PCN/22/009/C+N-US

Product Range: D-Subs

Title: D-Sub W - Change of contact plating on termination side

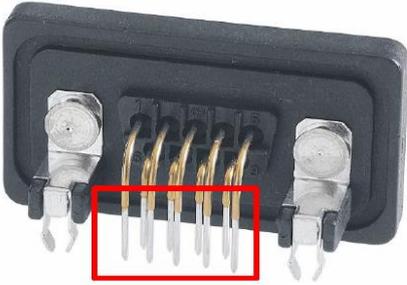
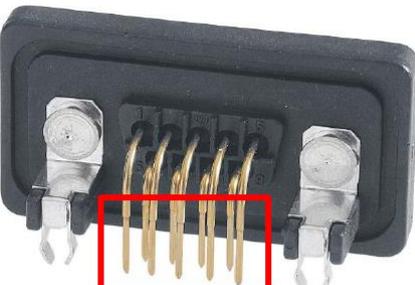
2. Description of Changes/News				
<p>To harmonize our D-Sub Portfolio with turned contacts, we are changing the contact plating of the IP67 D-Subs on the termination side to our common standard.</p> <p>Pre-tinning of the signal contacts in the termination area is omitted. The contact surfaces remain gold-plated throughout.</p> <p>Please find below the optical comparison of the old and new version.</p> <p>Example 9-Pin Version 09675096758:</p>				
Old Contact Finish	New Contact Finish

3. Impact on Product Specification
<p>There will be no impact on the function. Contact plating has been used for D-Sub Standard connectors since many years successfully.</p>
4. Scheduled Date of Implementation
<p>Last shipment (date): 12/02/2022 Please consider the currently long delivery times.</p>
5. Identification of Change
<p>Article numbers will remain unchanged. Revision level will be increased.</p>
